DOCKET 50-155 - LICENSE DPR-6 -
BIG ROCK POINT PLANT - STATION
ELECTRIC DISTRIBUTION SYSTEM
VOLTAGES AND DEGRADED GRID
PROTECTION

ADEQUACY OF STATION ELECTRIC DISTRIBUTION
SYSTEM VOLTAGES AND DEGRADED GRID PROTECTION

Big Rock Point Plant
Response to NRC Letter Dated July 7, 1981

DIAGRAM:

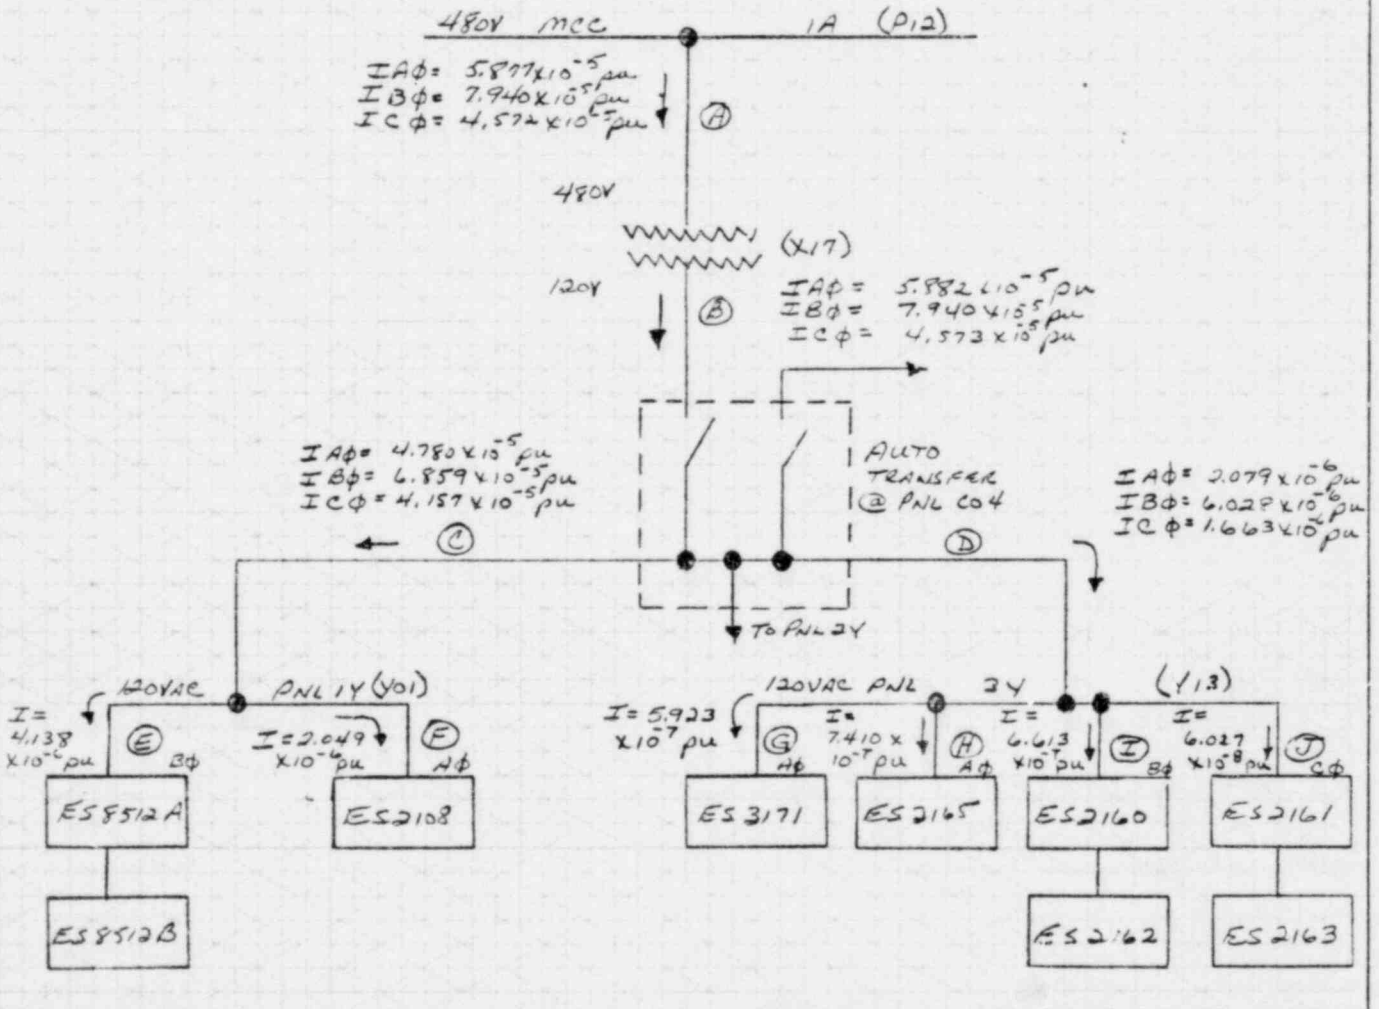
- 1) VOLTAGE DROPS FROM BUS 1A TO THE INSTRUMENT POWER SUPPLIES
- 2) VOLTAGE AVAILABLE AT POWER SUPPLIES CONSIDERING THE VOLTAGE DROPS DETERMINED IN 1.) ABOVE AND A BUS 1A VOLTAGE OF 0.9200 PER UNIT.
